**SEAL, EXTRUSION,  
T-SECTION**

**CVR 102**

REV: D,2 NOV 98

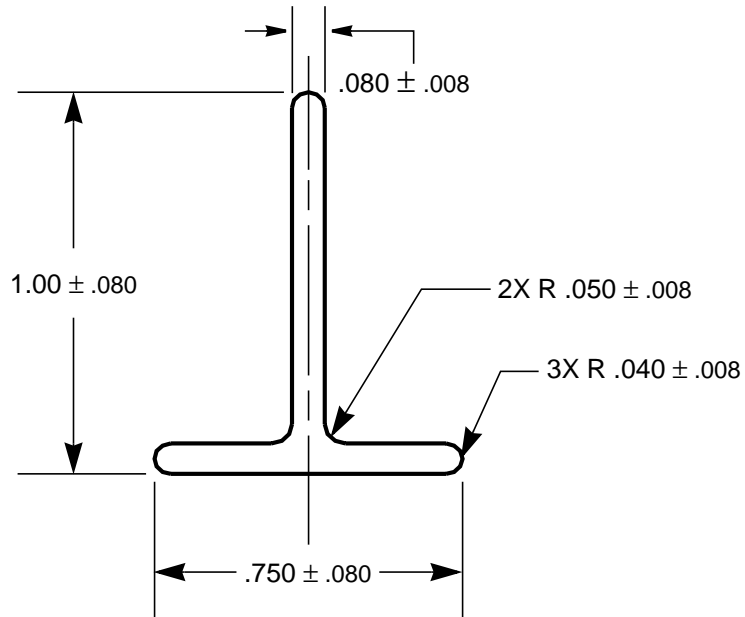
ⓓ a. ~~CVR102 - F.A.R. 25.853 (b-2) AMEND 25-51~~

ⓓ NOTE 2 MODIFIED (a DELETED AND b. ADDED)

b. CVR102-1 - F.A.R. 25.853 (b-2) AMEND 25-51 AND 45° BURN THROUGH TEST ONLY OF F.A.R. 25.855 (a-1) AMEND 25-51
